February 5, 2024  
IDEA Weslaco Mechanical Upgrades

## **ADDENDUM NO. 2**

IDEA WESLACO  
 02 MECHANICAL & ELECTRICAL RENOVATION PLAN (PORTABLES)  
 SCALE : 1/8" = 1'-0"

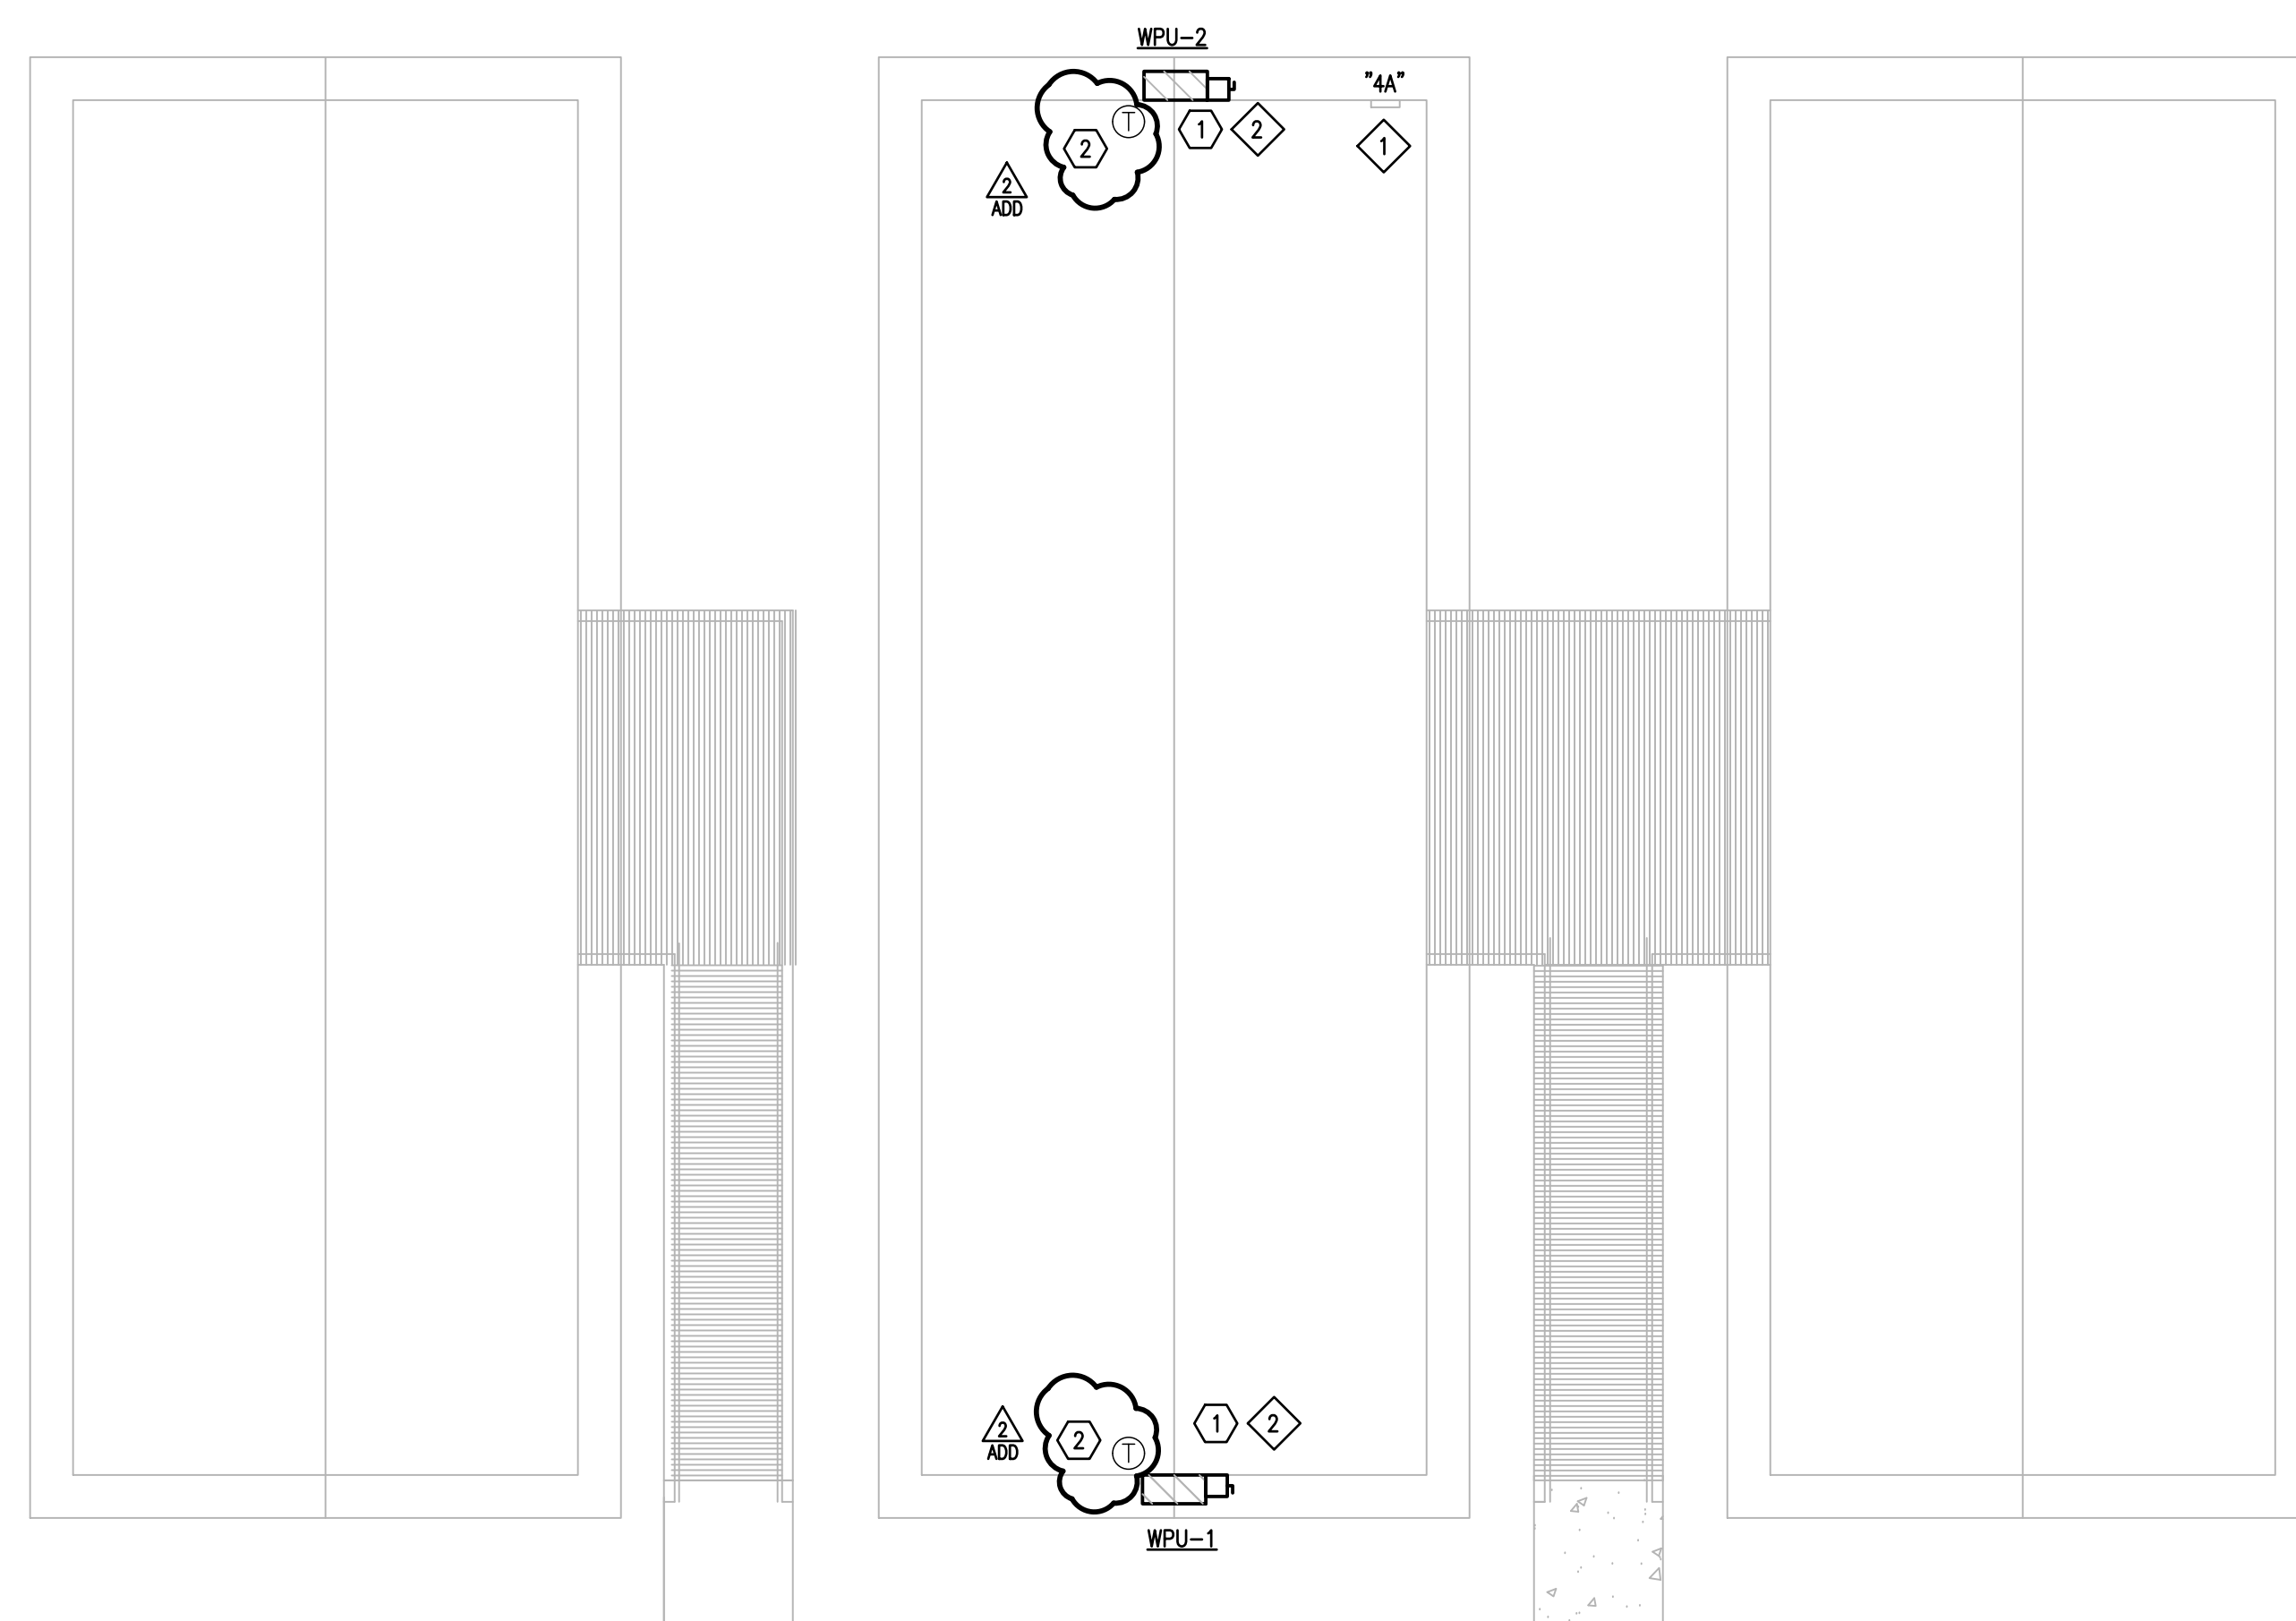
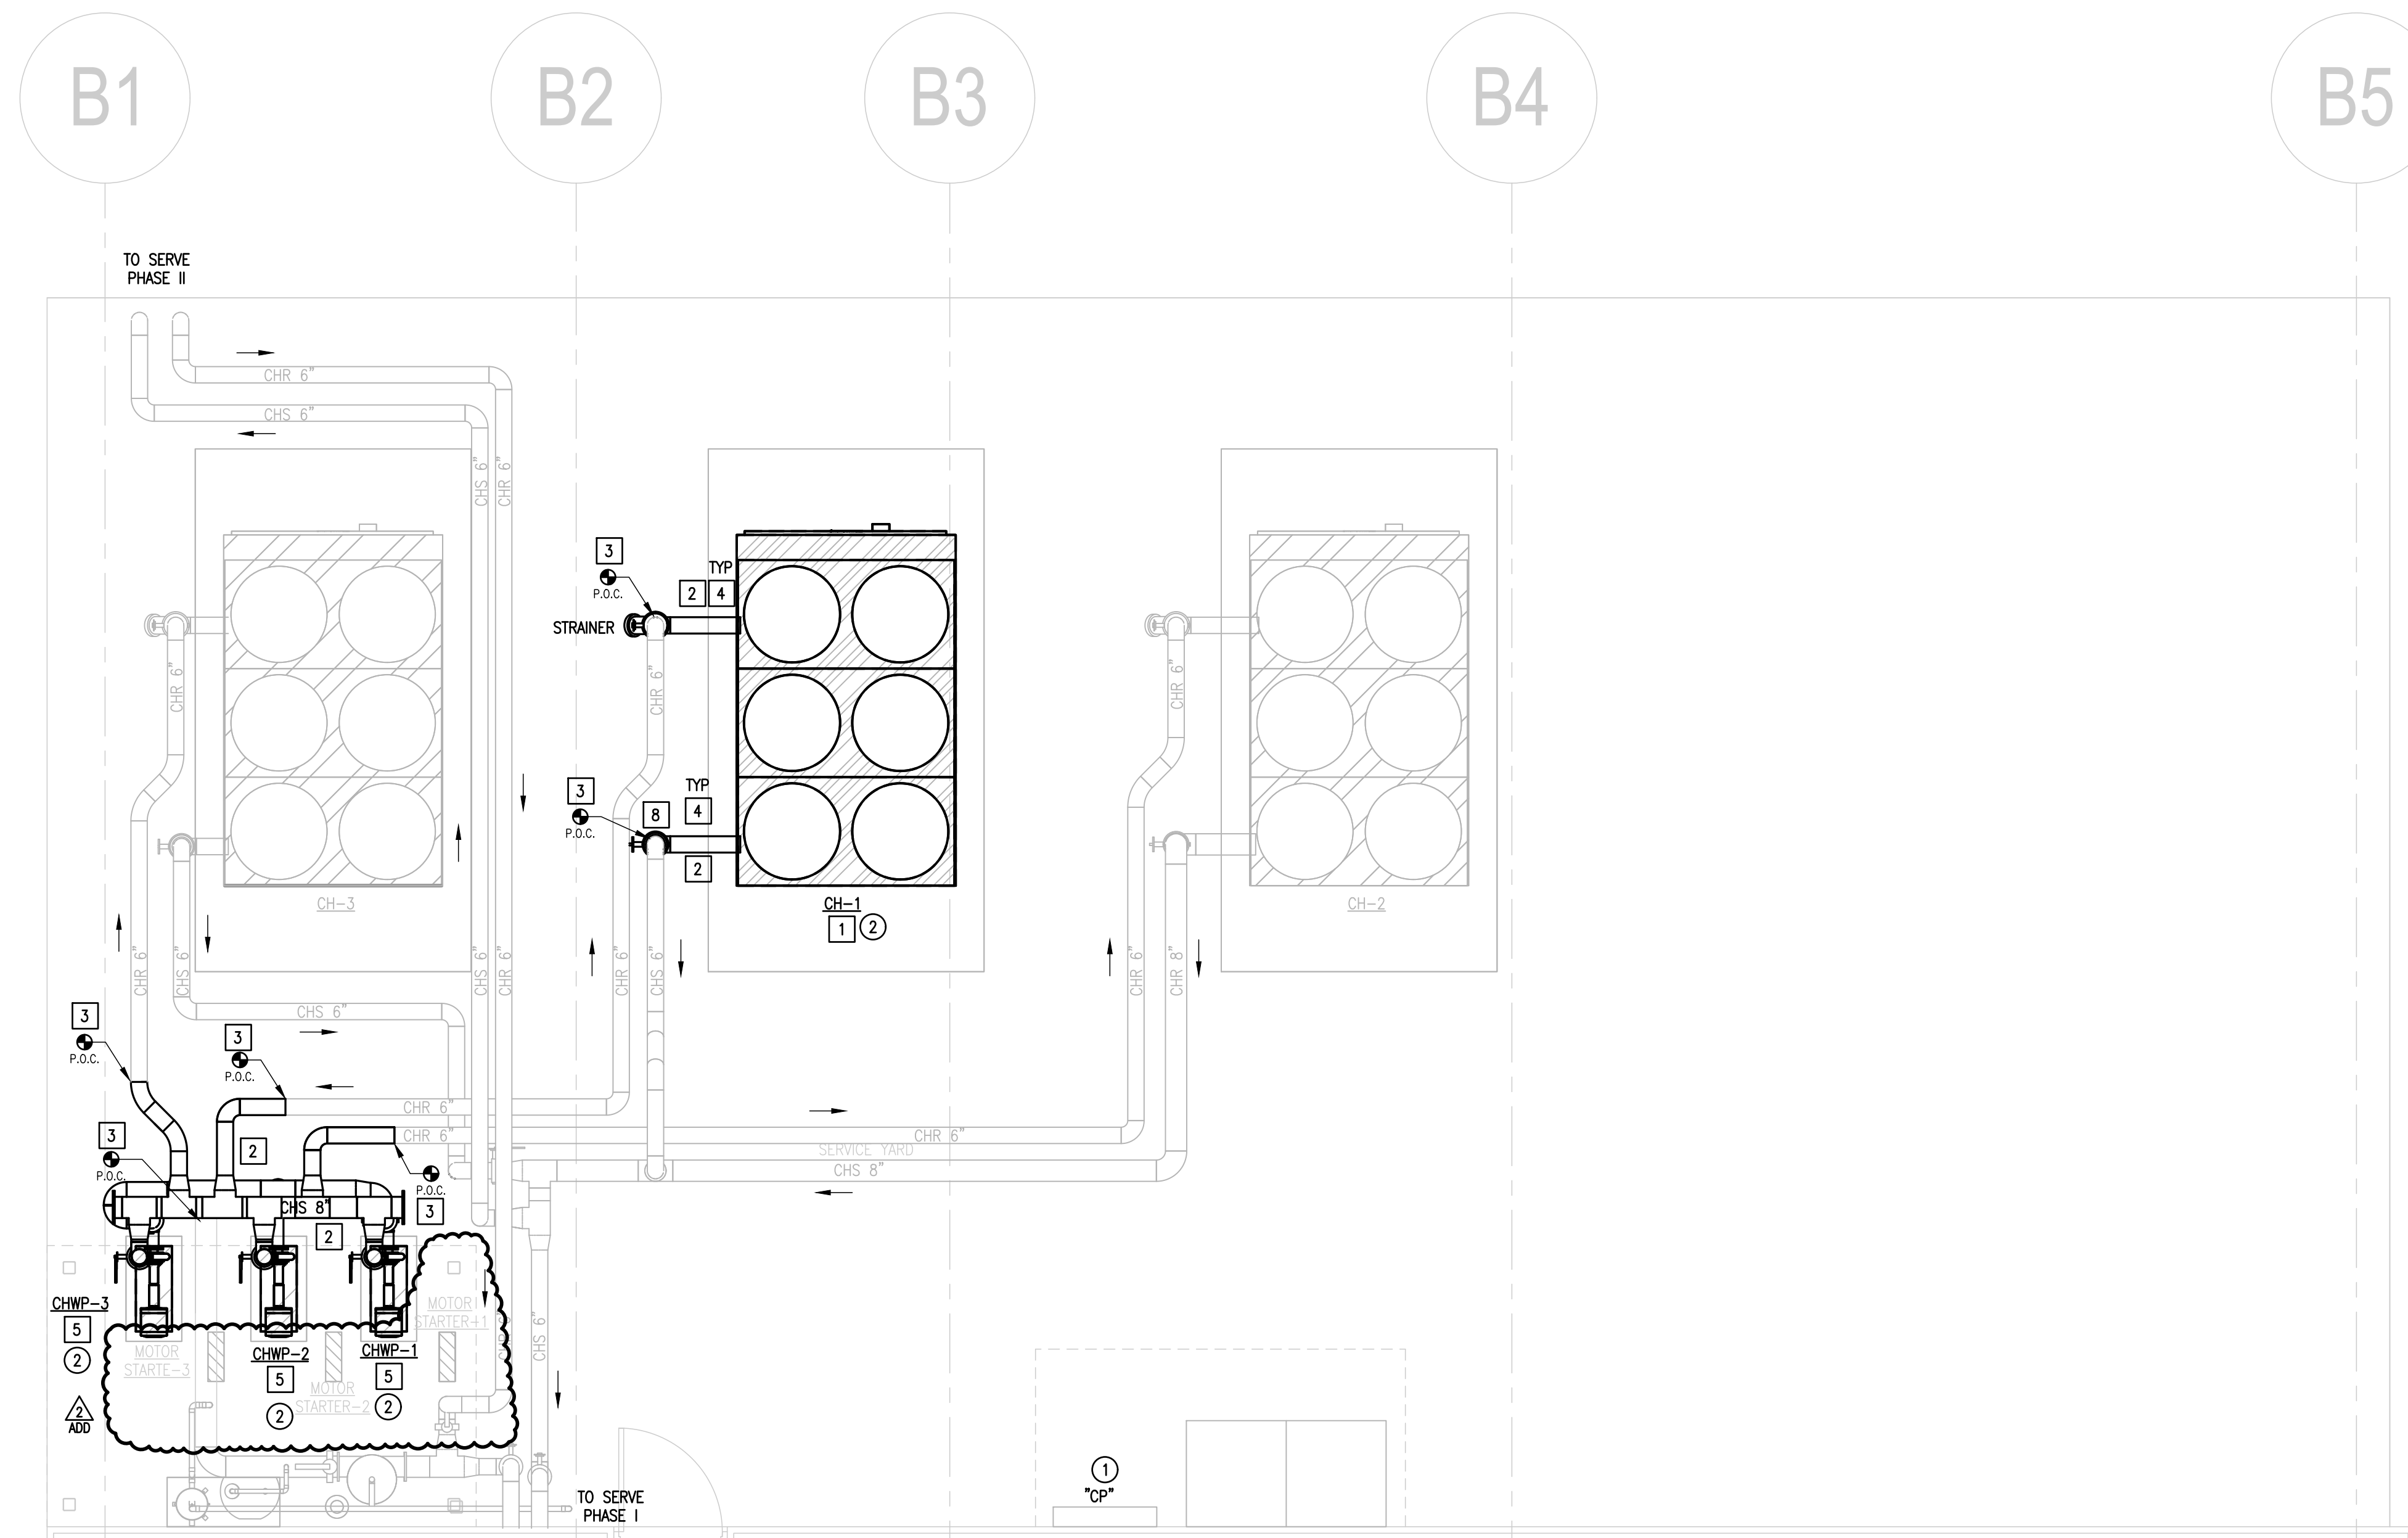
1. Sheet ME2.1:
  - a) Revised Mechanical & Electrical Demolition Plan. See attached sheet.
2. Sheet ME2.3:
  - a) Revised Mechanical & Electrical Renovation Plan. See attached sheet.
3. Sheet ME3.1:
  - a) Revised Mechanical & Electrical Renovation Plan. See attached sheet.
4. Sheet ME5.1:
  - a) Revised Equipment Connection Schedule. See attached sheet.
  - b) Revised equipment schedules. See attached sheet.
